REQUEST FOR INFORMATION DATE: May 31, 2016 NO.: RFI-135

Project Name: 15051-Webster University Interdisciplinary Science Building Project No.: 15051

Subject: Exterior EOS, L3 & L4 at 5 - C.3

PARTIAL LEVEL 03 & 04 PLAN

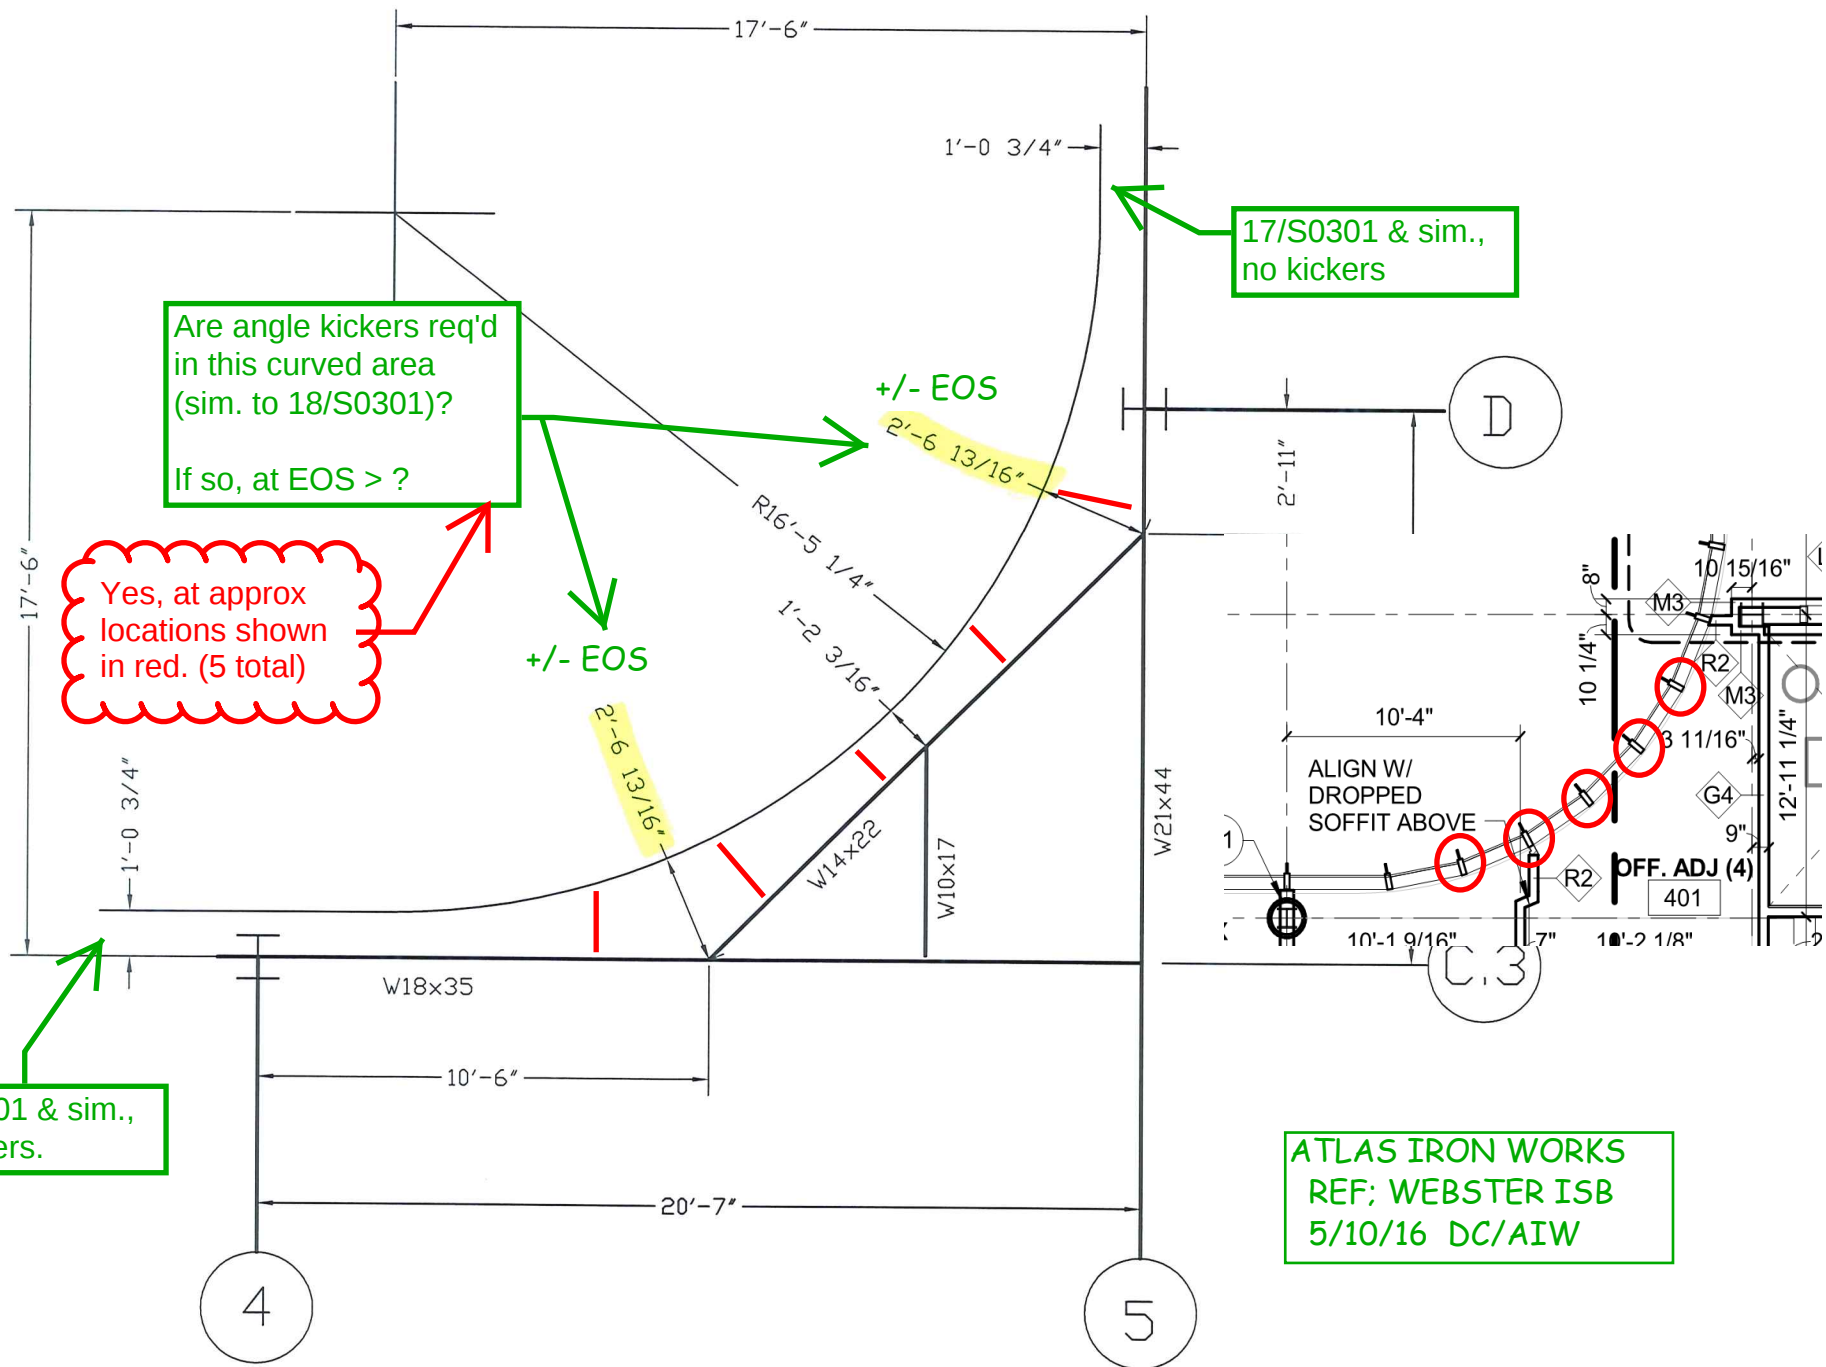
Please see the attached pdf concerning the exterior edge-of-slab at Levels 3 & 4 near column lines 5 – C.3; and advise if kicker angles will be required where the slab overhang increases beyond the 1'-0 3/4" (17/S0301) due to the radius.

- If kickers are required, please advise the parameters for locating them (EOS greater than ____?)
- Also verify that any kickers would not need to align with the curtainwall mullions.

FOR GENERAL INFORMATION AT EDGES, REFER TO DETAILS 26/S0002 AND 9/S0003. KICKERS SHOULD BE PROVIDED WHEN THE EOS EXCEEDS 1'-2". AT ROOFS, DETAIL 7/S0302 IS MISSING THE LINEWORK FOR THE EXTERIOR GUSSETS (AS ARE 4/S0302, 4&15&22/S0303, AND 13/S0304). TYPICAL ROOF EDGE DETAILS ARE TO FOLLOW 5&6/S0303. PREVIOUS CORRESPONDENCE WITH ATLAS ALSO ATTACHED.
